WATER DISTRIBUTION SYSTEM

STAR LUMBER

3601 W. WALKER ST.

AS BUILTS	
Contractor:	Project Inspector:
Ewertz Excavation	Larry Gann
3/28/2023	
117 E. Lewis, Wichita, KS 67202 (316)264-0242

592' E & 34' S

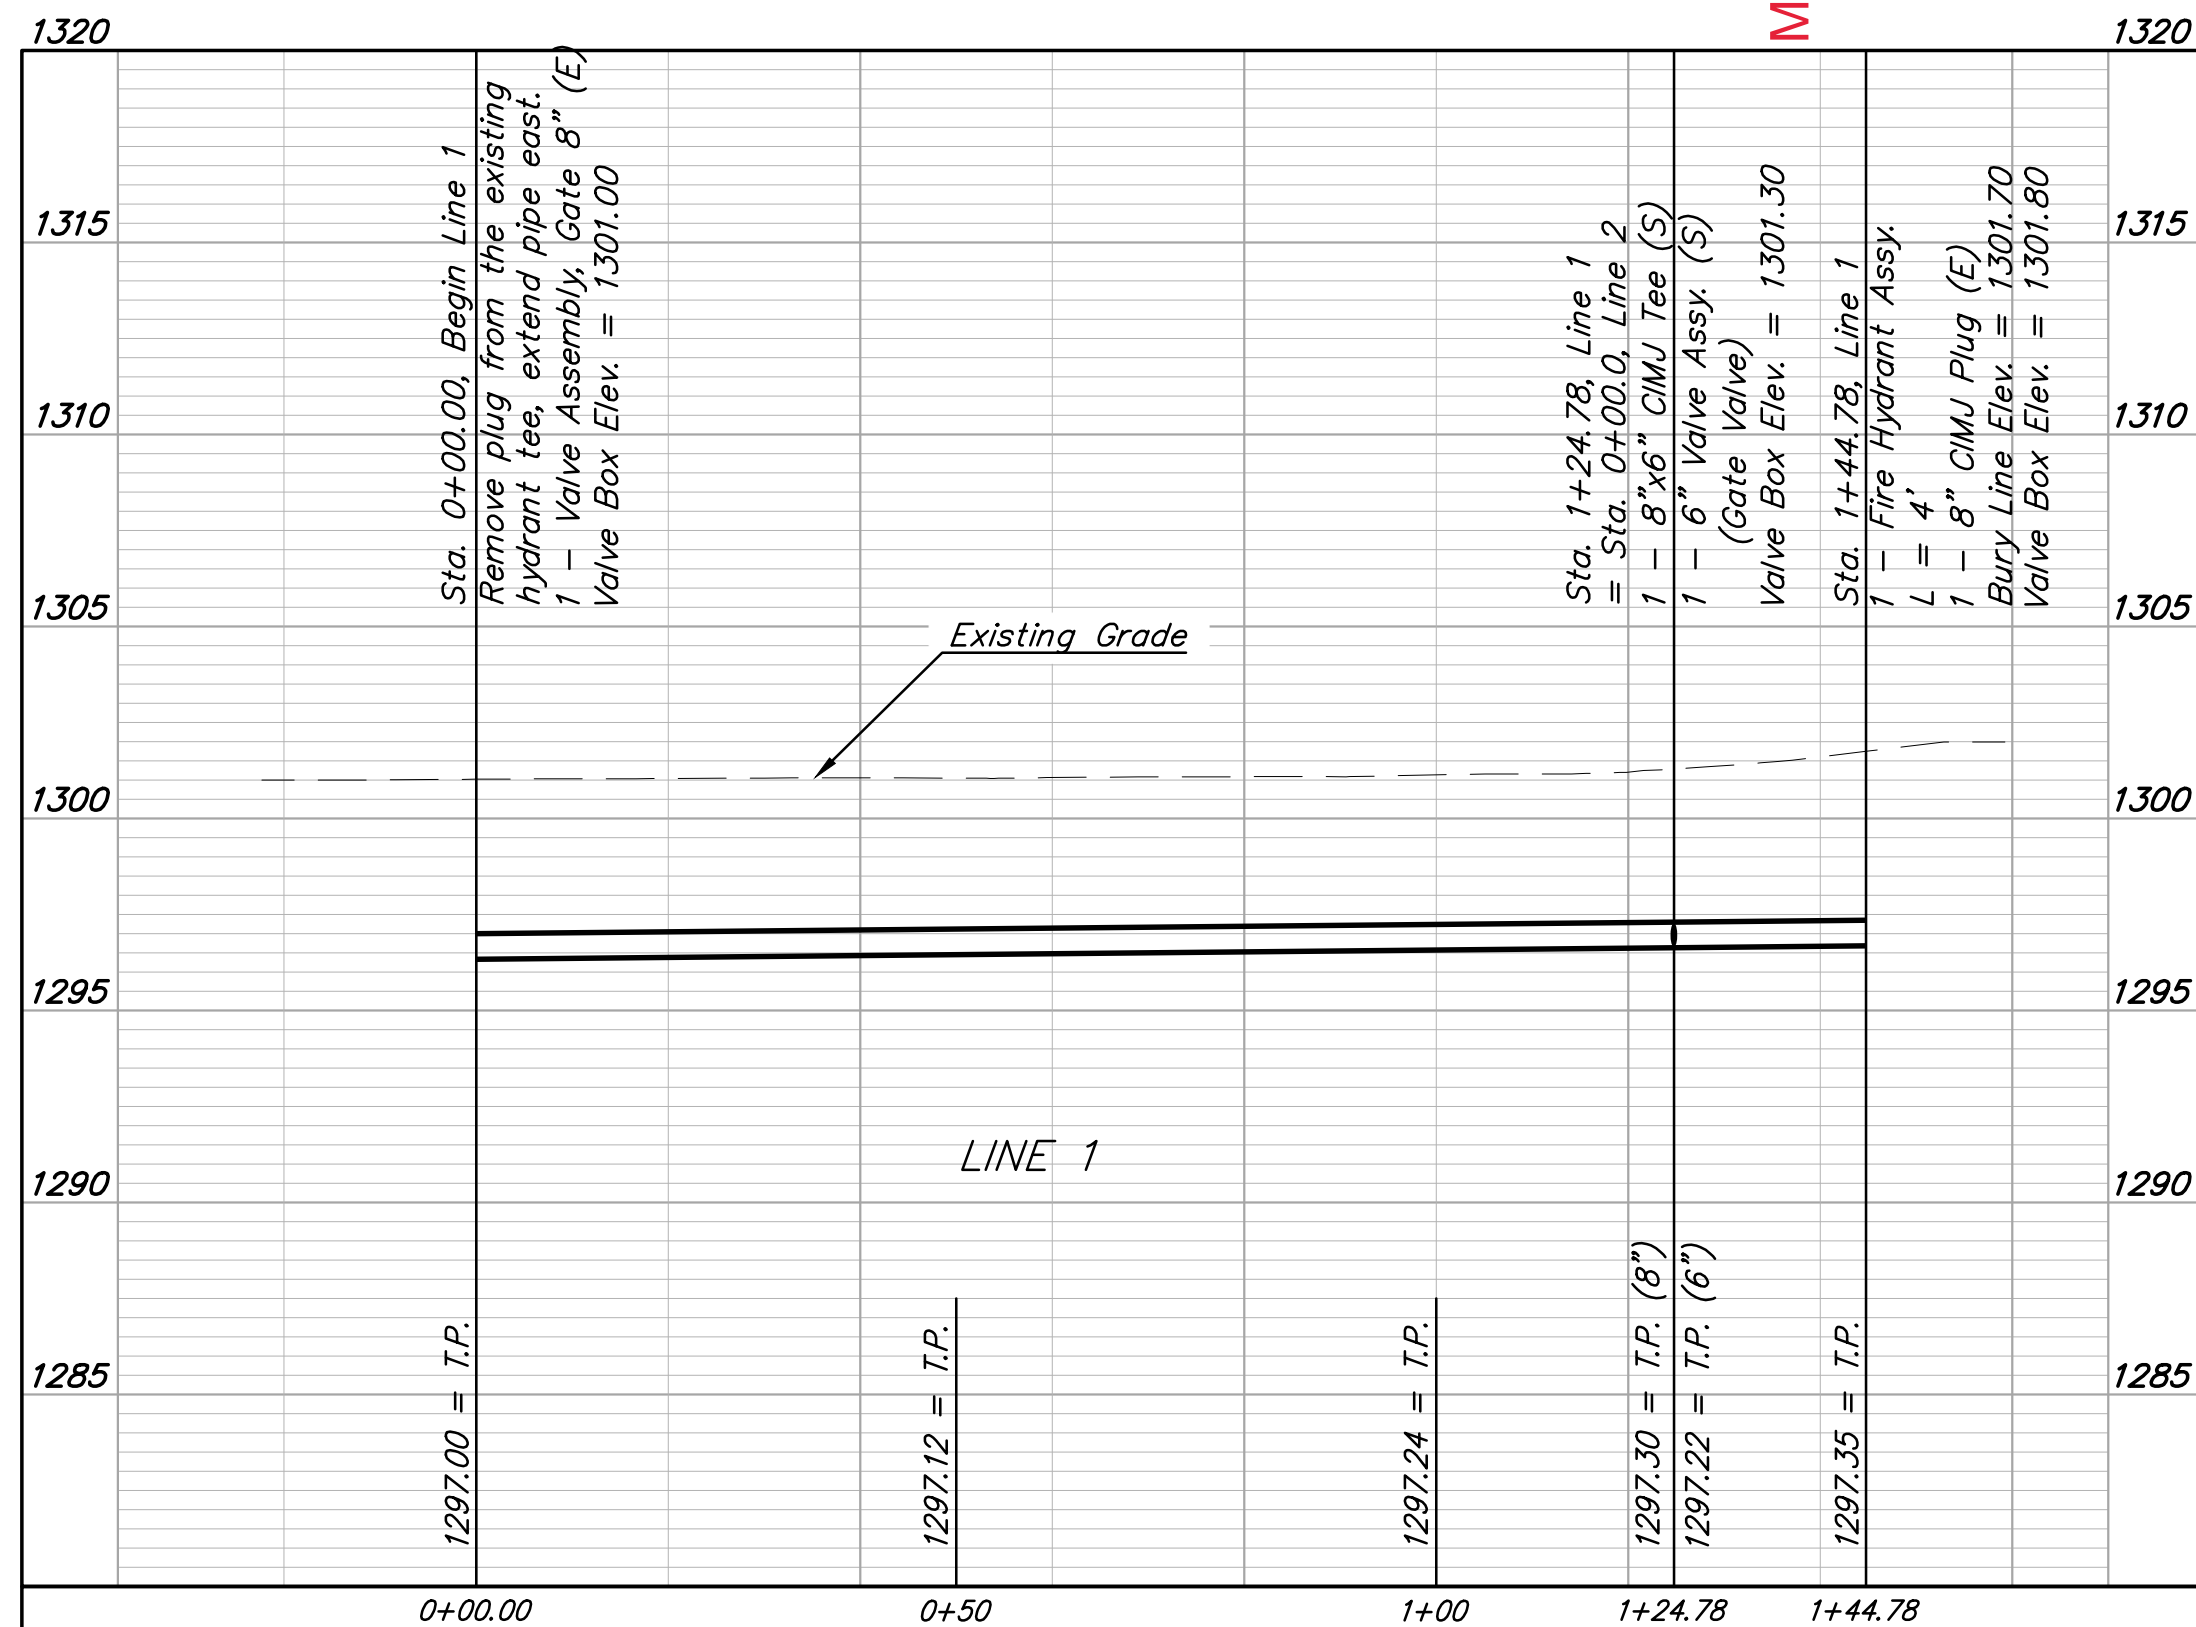
*All connections to
directional drill pipe
must be restrained joint

FH MOVED
1'10" west
